Preferred Project Report

166 - 174 Hawkesbury Road, Westmead
Westmead Millennium Institute and
Westmead Research Hub

Submitted to
Department of Planning
On Behalf of Health Infrastructure

December 2010 ■ 09434

Figure 2 – Photomontage Hawkesbury Road east

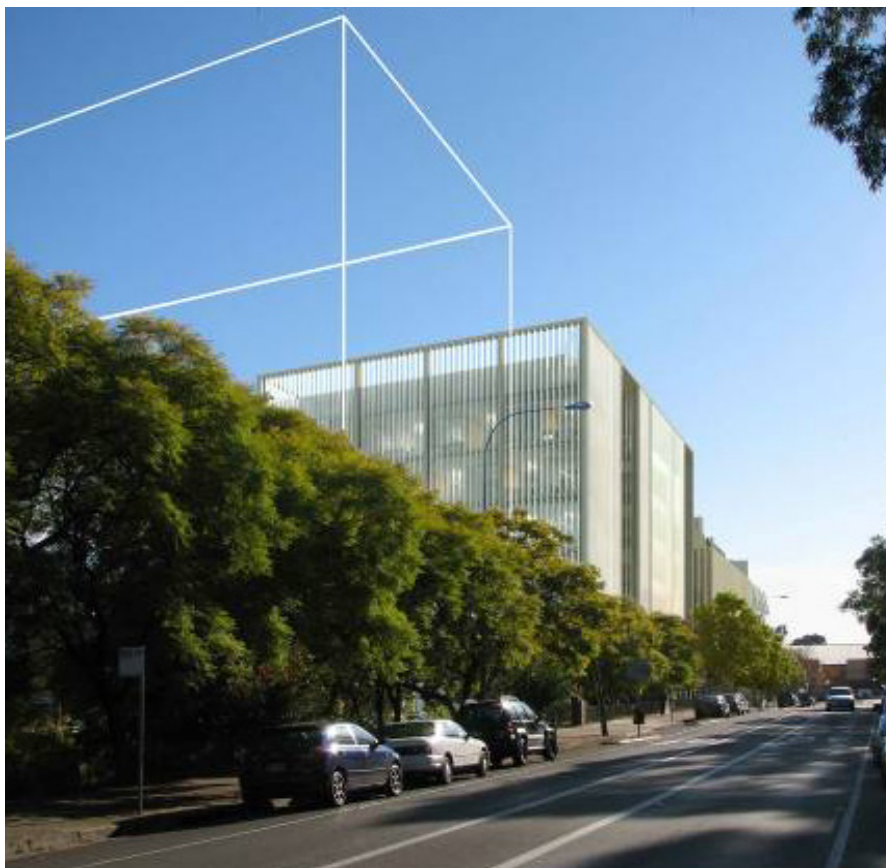
Consideration should be given to setting back the upper levels of the development, to better complement the existing streetscape and scale of the approved CMRI.

As evidenced above, the Hawkesbury Road streetscape is undergoing considerable change. It is this future setting that the proposed development seeks to respond to. The photomontage images prepared in support of the Project Application illustrate the future appearance of the streetscape along this section of Hawkesbury Road (refer to **Figure 2** and **3** below). In viewing these images, regard needs to also be had to the form of future development planned along the full length of Hawkesbury Road.
